COMMENTS AND RESPONSE REPORT

Bitou Local Municipality: Land Use Management (Spatial Planner) on Pre-App DBAR	
Comment	Response
<p>The proposed residential use is supported in principle, in light of the context of the property and the Municipal Spatial Development Framework.</p>	<p>Noted.</p>
<p>However, the application is silent on the existing public access/ pathway to the estuary which traverses the subject property. During the pre-application I suggested that this aspect be addressed, as it has quite a significant bearing on the application in my view. The alignment of the road reserve/ servitude adjacent to the subject property to the estuary is not practical, thus the need for the pathway to traverse the property as it currently does. The pathway has been in existence for at least the last 20 years as far as I can establish from aerial imagery, but has likely been in use for significantly longer. The applicant should clarify how the pathway will be dealt with, and possible approval conditions be inserted to this effect – we want to avoid a situation where the property/ pathway will be fenced off as part of the property’s “Private Nature Reserve”, thus preventing public access

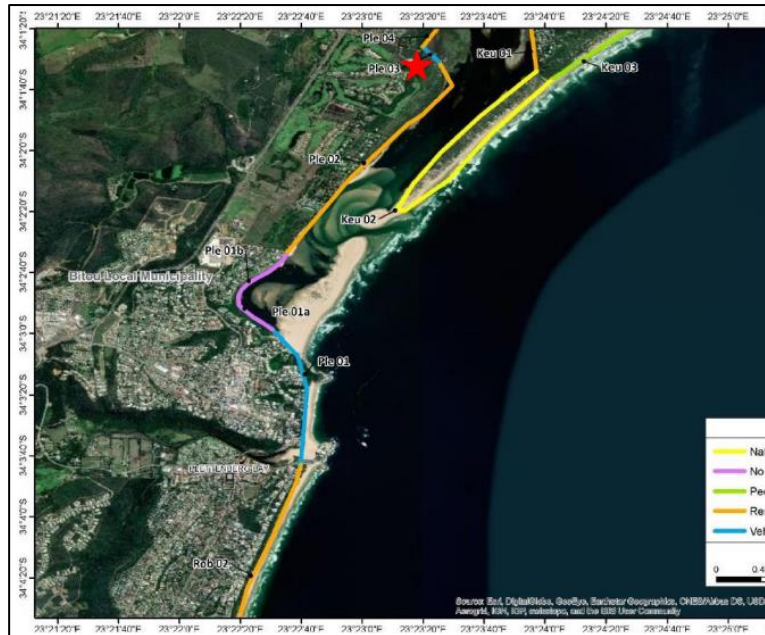
ensure that adequate provision is made in the conditions of approval to secure public access to that coastal public property”. A Coastal Access Audit has been undertaken for the Garden Route District (WCPCASP, DEA&DP, 2019).

It is proposed for the gravel parts of Rietvlei Road to be hard surfaced up to the entrance of the proposed development within the constraints of the existing road. Hard surfacing the gravel road will improve accessibility for the public to the coastal environment.

The pending town planning application will be amended to also include an application for subdivision to allow for the registration of a public right of way servitude. Once the town planning application has been approved, the area must be surveyed, and new servitude diagrams must be submitted to the Surveyor Generals office for approval. At that point, the HWM can be surveyed should it be deemed necessary to subdivide the lower lying area below the HWM for (administrative) transfer to the State.

Figure 1: Minimum required upgrade to the existing 75mm diameter pipeline within the Rietvlei Road road reserve to comply with the fire flow criteria. Note that the original 17 unit proposal considered by GLS has since been reduced to 12 units (GLS Consulting, 2022).

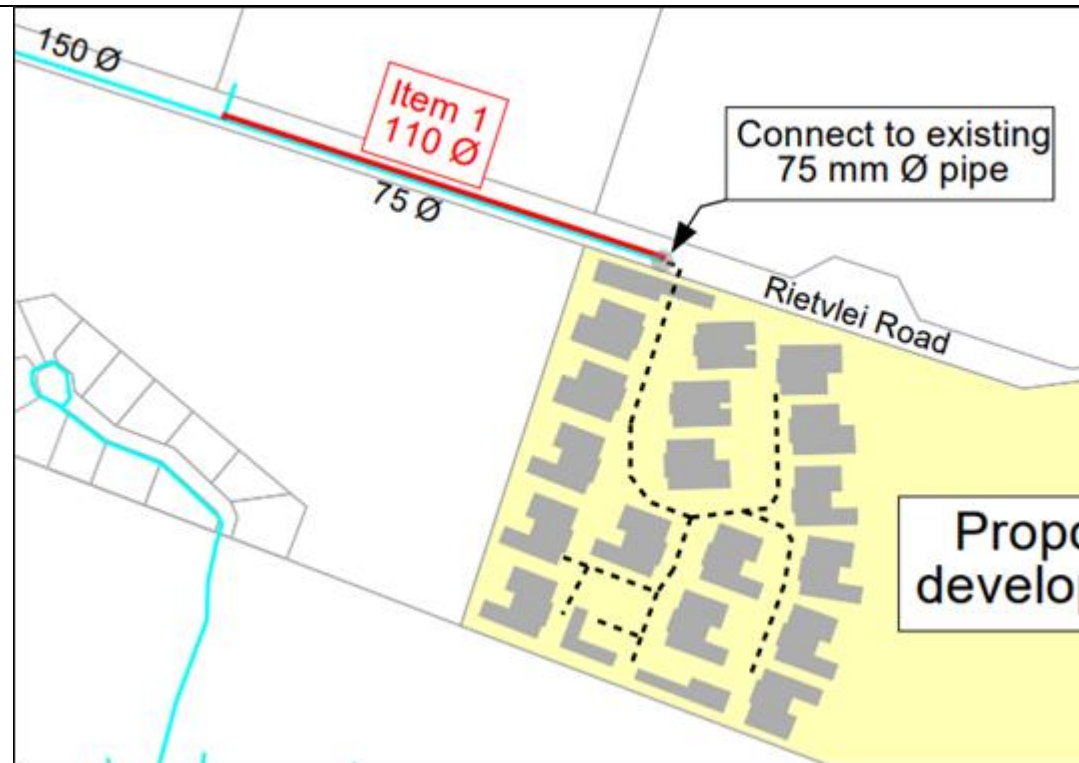
<p>We would require assurance that the increased potable water requirement would not impact on the elderly residents of Quartet, with particular regard to the Temporary Water Solution, as proposed.</p>	<p>Please see extract from Civil Engineering Report regarding the bulk water supply capacity for the proposed development.</p> <p><i>“The bulk water system to the Goose Valley, Wittedrift and Matjiesfontein reservoirs is at capacity and should be upgraded according to the master plan before additional developments within the reservoir supply areas can be accommodated.</i></p> <p><i>Various meetings with GLS and Bitou municipality was held to discuss a proposed interim solution to increase the bulk supply to the Goose Valley Reservoir. GLS provided the following temporary solution:</i></p> <ul style="list-style-type: none"> • <i>Installation of an additional 160mm bulk main off the existing 160mm distribution main in the N2 road reserve (refer figure 5) which will free up an additional 860kl/day.</i>

According to the GLS (municipal) services investigation, the existing **75mm diameter pipe** in Rietvlei Road road reserve needs to be **upgraded to a 110mm diameter pipe** (extending approximately **220m** long) in the Rietvlei Road reserve in order to comply with the **fire flow criteria** (Item 1 in Figure 1).
